**CITY OF NAPLES  
PURCHASING DIVISION  
CITY HALL, 735 8<sup>TH</sup> STREET SOUTH  
NAPLES, FLORIDA 34102  
PH: 239-213-7100    FX: 239-213-7105**

**ADDENDUM NUMBER 2**

| NOTIFICATION<br>DATE: | BID TITLE:   | BID NUMBER: | BID OPENING DATE & TIME: |
|-----------------------|--|-------------|--------------------------|
| 4/04/12               | City of Naples – Sidewalk Installation<br>River Park | 033/12      | 04/20/12<br>2:00PM       |

**CROSS-SECTION  
B-B**

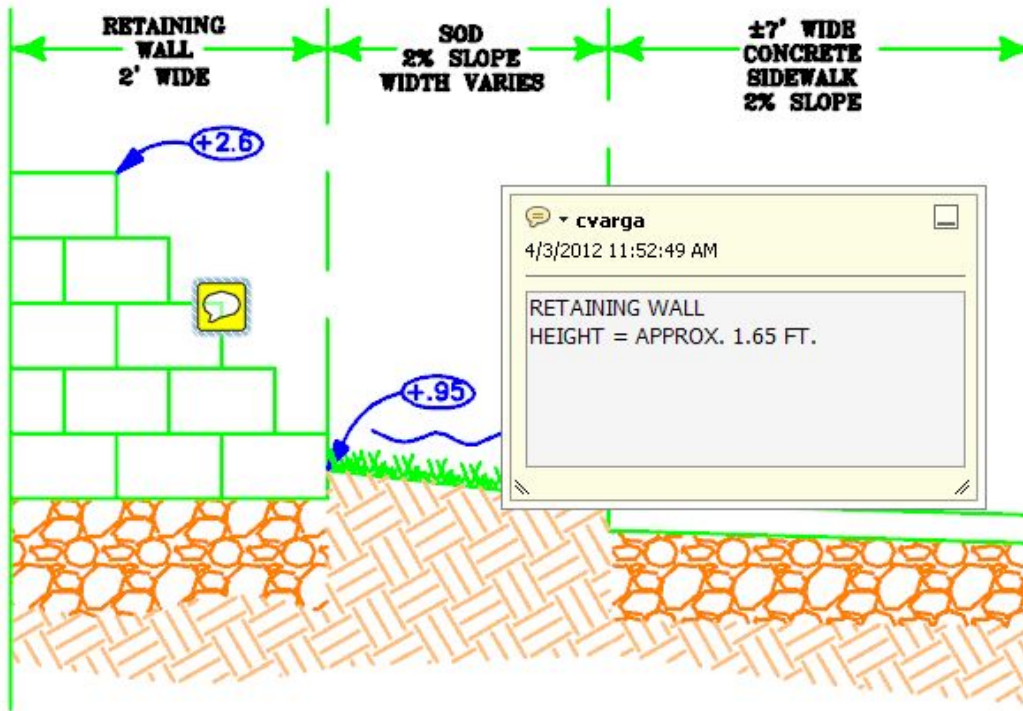
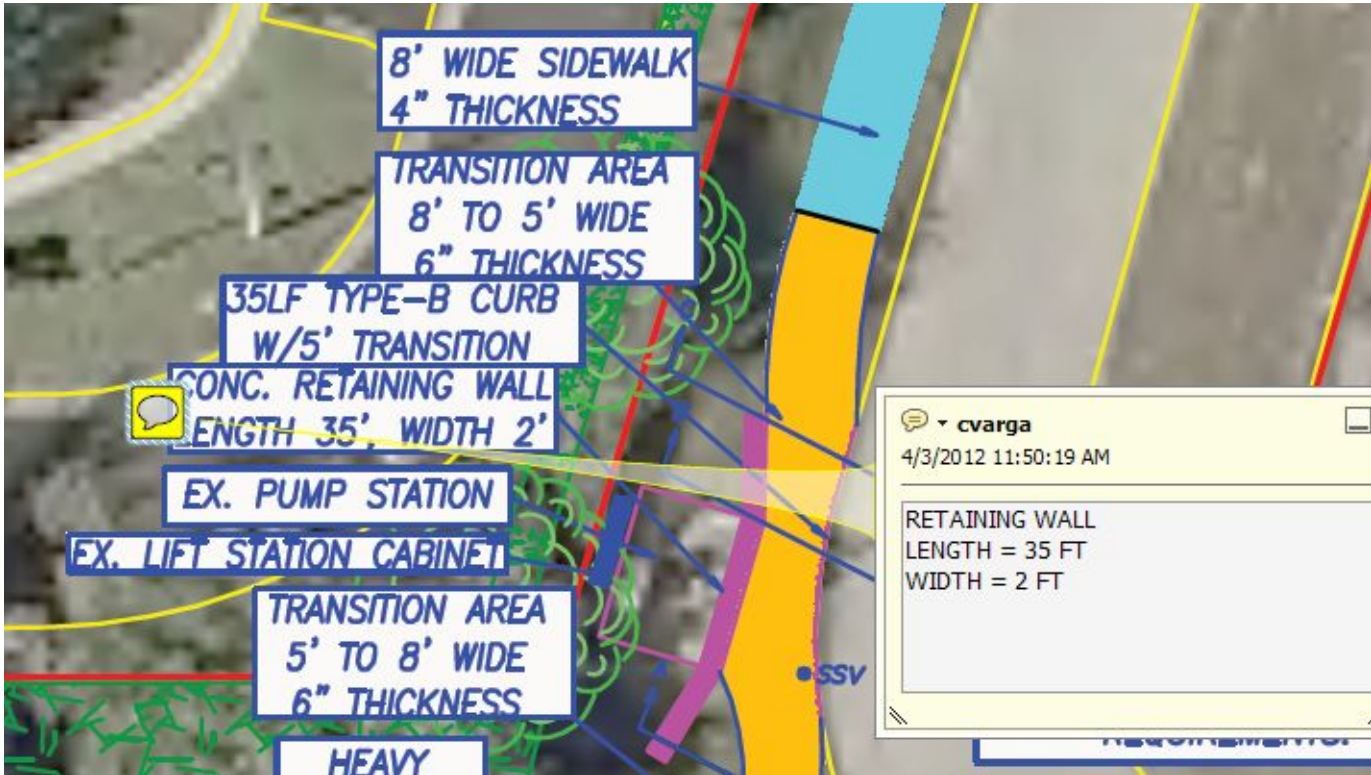
CLARIFICATION OF THE WALL DESCRIPTION (Item 13, Page 7 of Addendum 1):

The concrete retaining wall denoted on the plans and bid tabulation shall be defined as an interlocking gravity retaining wall system utilizing a minimum block size of 4" high x 8" wide x 8" deep and shall not exceed 8" high x 12" wide x 12" deep. Color samples shall be provided to the Engineer prior to ordering retaining wall for color determination. Installation methods shall be installed per manufacturer's standards. All references to a retaining wall for this project shall meet the requirements as specified.

HEIGHT: 1.65 FT  
LENGTH: 35 FT  
WIDTH: 2 FT
